## Hume Planning Scheme Amendment C241 Craigieburn West Precinct Structure Plan

**Date of Statement:** 19 April 2021

**STATEMENT TO ADVISORY COMMITTEE BY JASON LEE WALSH, TRAFFIC ENGINEER**

Figure 4: Transport Plan with Subject Land (November 2020)

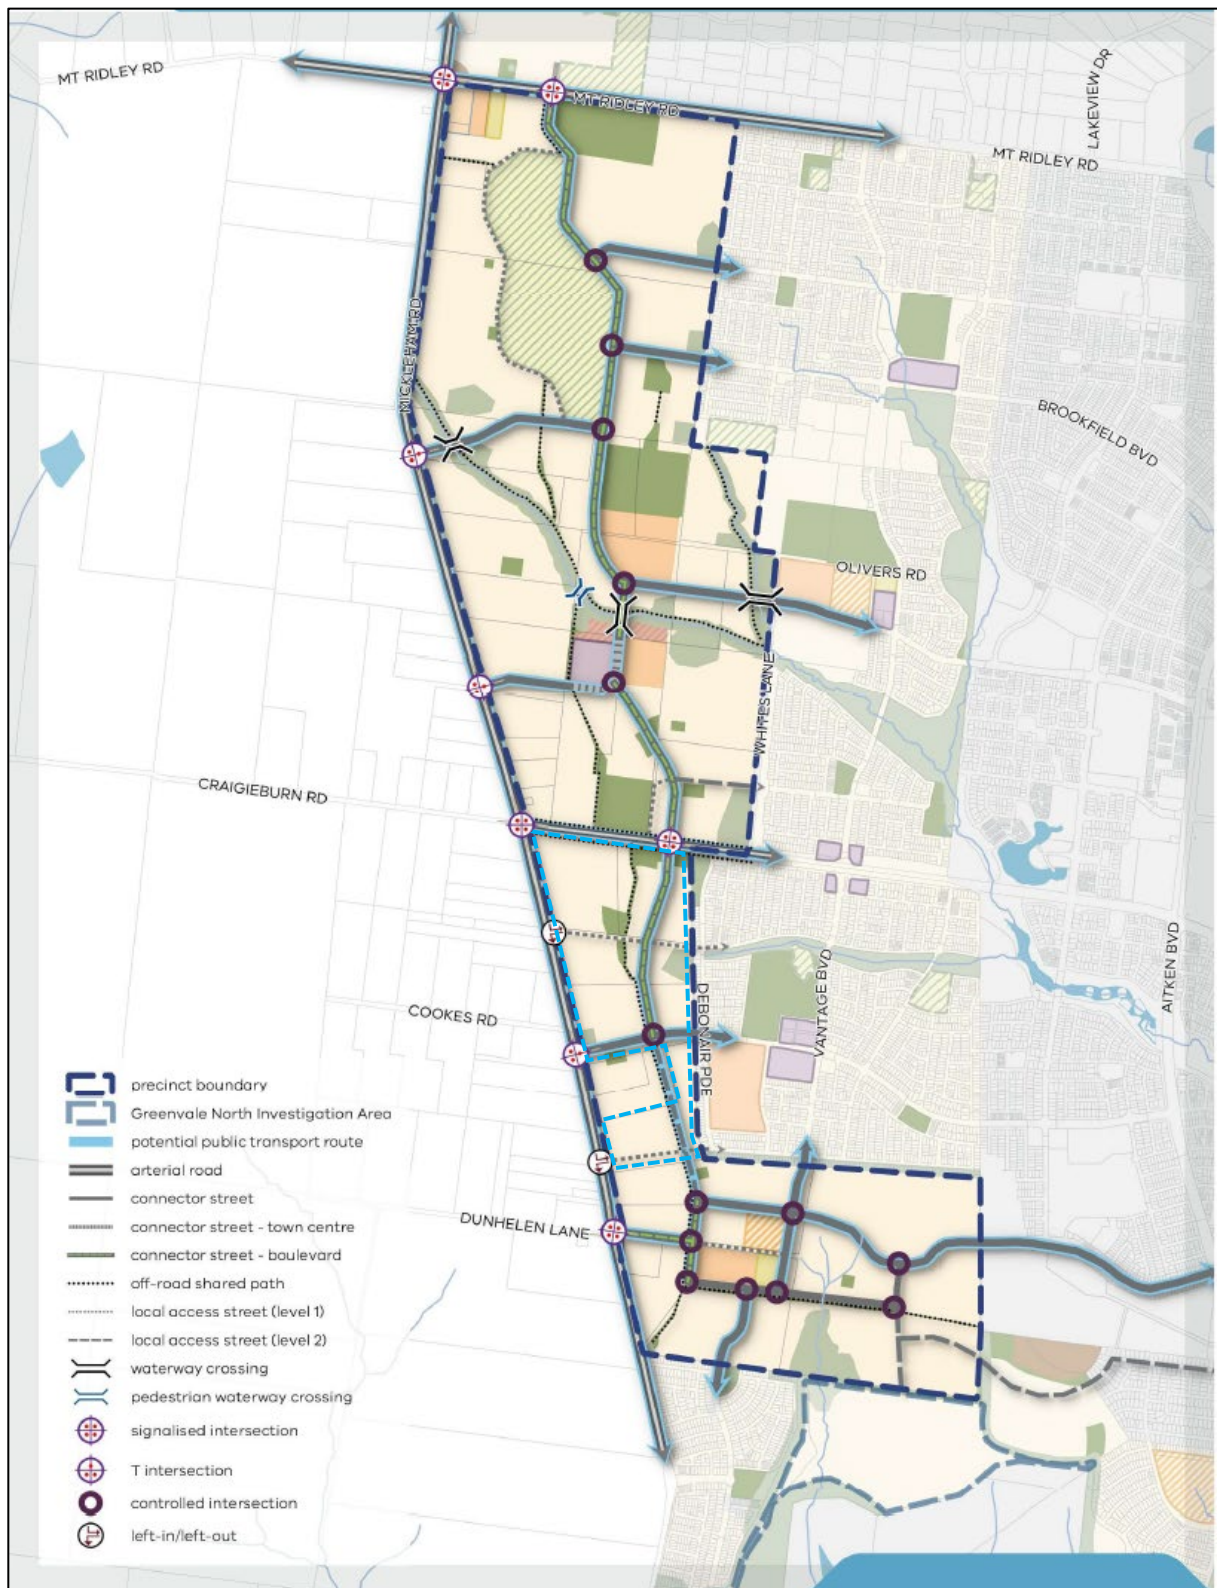
- 30 Peet propose to retain the intersection of the north-south connector street and Craigieburn Road as drafted in the PSP, however as the connector street travels to the south, Peet propose an alteration to the alignment, such that the alignment moves to the west. This is proposed with open spaces changes and to allow delivery of the stormwater management strategy.

- 31 The proposed Peet alignment is preferable from a traffic perspective, as it is more centrally placed between Mickleham Road and Debonair Parade.
- 32 The connector street is largely contained in Peet's land, and even though proposed to be aligned further west remains in Peet's land. In this regard, there is no material impact that results from the change.

- 34 Therefore, I am of the view Peet's preferred alignment should be adopted.
- 35 Peet also propose to downgrade the north-south connector street (boulevard) to a bus capable access street (level 2) with a reservation of 21 metres.

- 37 In relation to the north-south connector street, the traffic addendum highlights the revised modelling projects the north-south connector street (between Craigieburn Road and Elevation Boulevard) will have a daily volume in the order of 5,000 vehicles. On this basis, the report recommends a downgrade of the nomination of this section of road from a connector street (boulevard) to a connector street.

- 38 Based on the projected daily traffic volume, I am of the opinion this is the correct nomination for the road and agree with the proposed VPA amendment.

- 57 Based on the preceding assessment, I am of the opinion:
- a) The PSP should be amended to adopt the Peet preferred alignment for the north-south connector street / bus capable access street (level 2) between Craigieburn Road and Riverglen Drive.

- b) The north-south road, between Craigieburn Road and Elevation Boulevard, should be amended to a connector street as recommended by VPA in its Part A submission.

**Connector Street - Adjacent Linear Reserve (23.0 m)**  
Residential

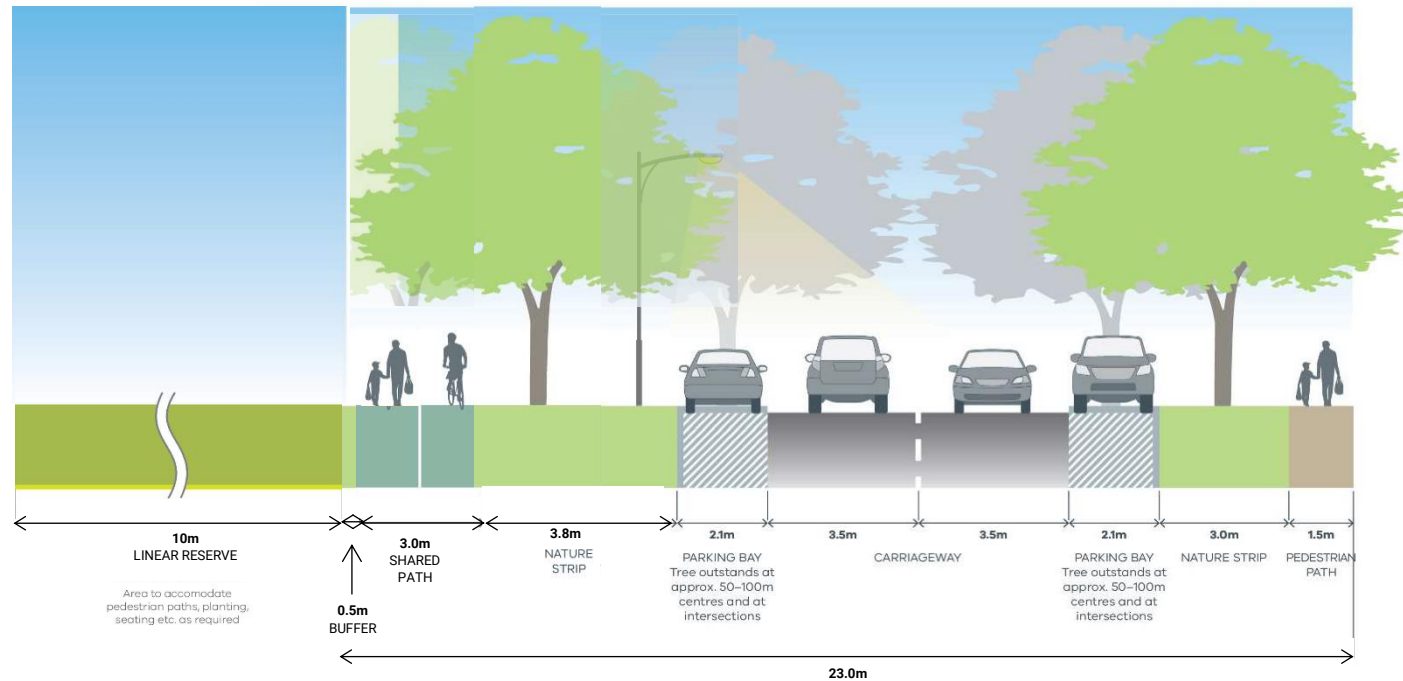
- Have a standard width of 15 metres or 10 metres where adjacent to a connector road, unless otherwise agreed by the responsible authority.
- 42 The north-south connector street is aligned with the north-south linear open space for a portion of its length. When this occurs, the effective cross section will include a shared path, a footpath and two-way bicycle path.

- 43 In my view, this is an unnecessary duplication of facilities, and perhaps the PSP nominated reduction in width of the linear park from 15m to 10m in this circumstance is suggesting there is no need for the shared path, but it is not clear.

- 44 I am of the opinion the PSP should include a cross section that clearly shows how the connector street and abutting linear park is to function.
- 45 Similarly, there should be a cross section for how the linear park, and bus capable access street (level 2) is to function.

- 46 In my view, the cross sections, should simply include a shared path on the linear open space side and a pedestrian path on the other side.
- 47 Example cross sections for these roads are attached as Appendix C.

- c) The PSP should be amended to include cross sections for the instances where the linear park abuts the north-south connector street and north-south bus capable access street (level 2). The recommended cross sections are attached as Appendix C.
